UNITED STATES PATENT AND TRADEMARK OFFICE

APPLICATION NO.	FILING DATE	FIRST NAMED INVENTOR	ATTORNEY DOCKET NO.	CONFIRMATION NO.
10/801,364	03/16/2004	Qingfa Huang	14687-0001	3158
3490	7590	11/02/2006	EXAMINER	
DOUGLAS T. JOHNSON MILLER & MARTIN 1000 VOLUNTEER BUILDING 832 GEORGIA AVENUE CHATTANOOGA, TN 37402-2289			MORGAN JR, JACK HOSMER	
			ART UNIT	PAPER NUMBER
			3782	
DATE MAILED: 11/02/2006

Office Action Summary

DETAILED ACTION

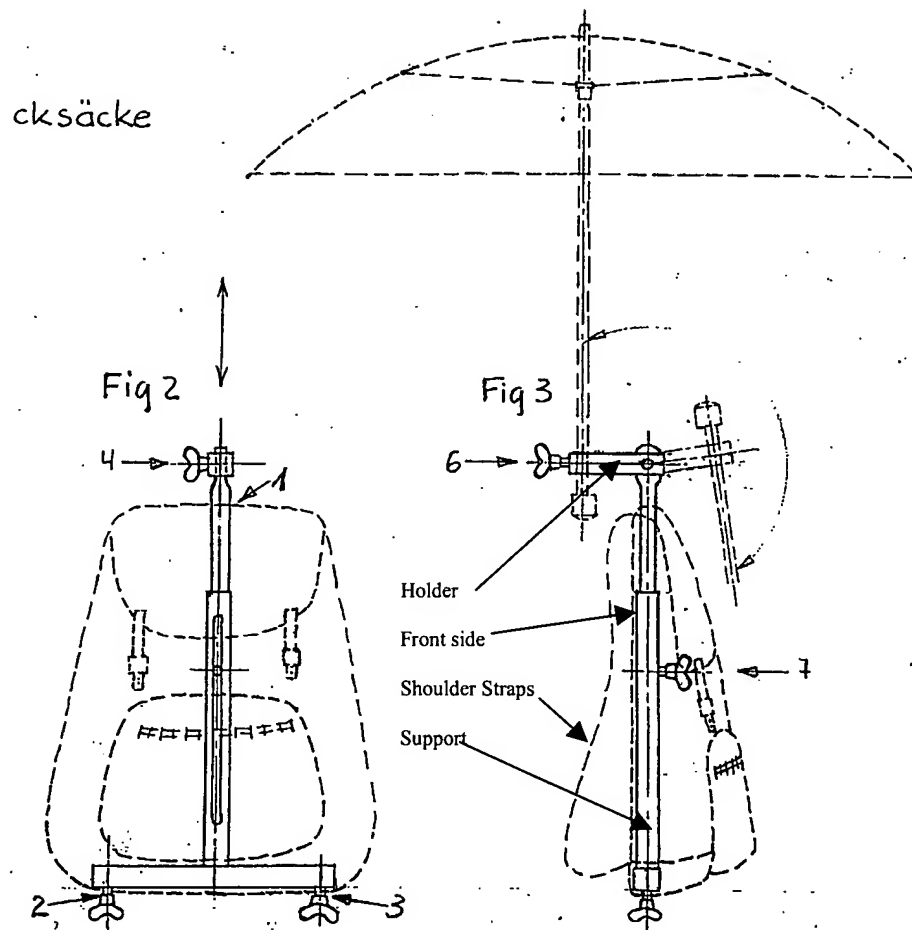
5. Claims 1-6, 8 and 10-12 are rejected under 35 U.S.C. 102(b) as being anticipated by Schmid (DE 29712815). Schmid discloses a backpack (see fig 3, also next page) with a front side and shoulder straps, also having an umbrella support having a top with a holder and an umbrella releasably connected to the holder, where the holder is tilted towards the front side of the backpack at an angle.

In regards to claims 2 and 10, the umbrella support is a round bar, thus having a curved front surface that conforms to the shape of a back. The front of the backpack is made of canvas, so it naturally takes the form of the back it is resting on.

In regards to claim 3, the angle of the holder is not set to a certain degree, thus being able to be in a range of 5 to 20 degrees.

In regards to claims 4 and 8, the umbrella handle and holder are connected by screwing (6).

In regards to claim 5, the umbrella holder is parallel to the back of a user.

In regards to claim 6, the umbrella support is installed in a slot within the backpack.

In regards to claims 11 and 12 the umbrella support is connectedly secured to the backpack by screws (2 and 3)
